100 Marsac Avenue, Steep Slope CUP Design Review.

First response to Planning Staff report (10 22 08) by Peter Barnes at the request of Jamie Thomas on behalf of Ontario Ct Driveway Association

Much of the original report is reproduced here with responses shown in italics.

UNIT 7
SOUTH ELEVATION

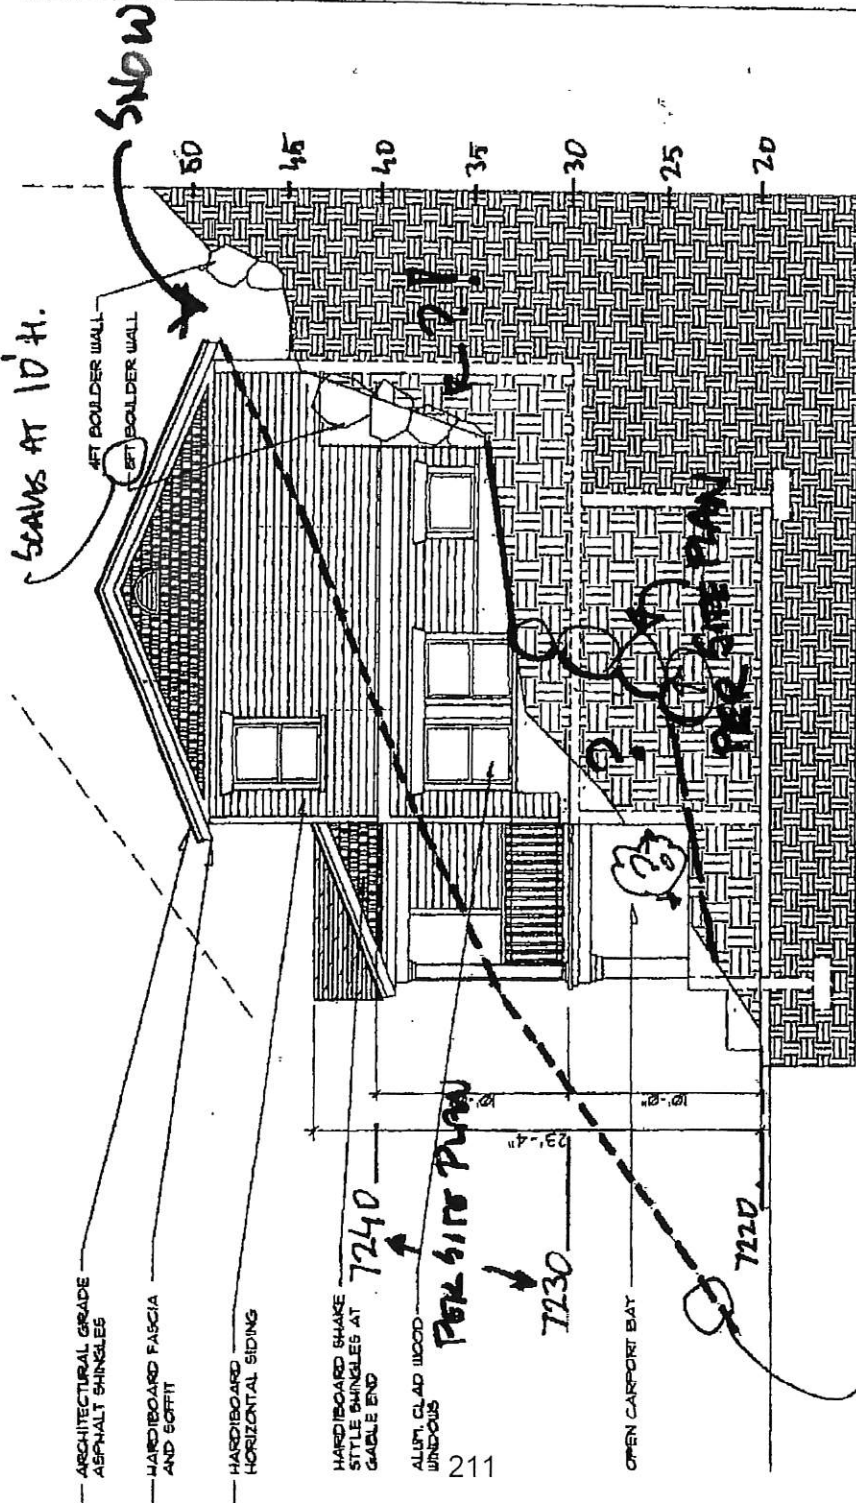
ROCK WALL LOCATION DOES NOT MATCH SITE PLAN.
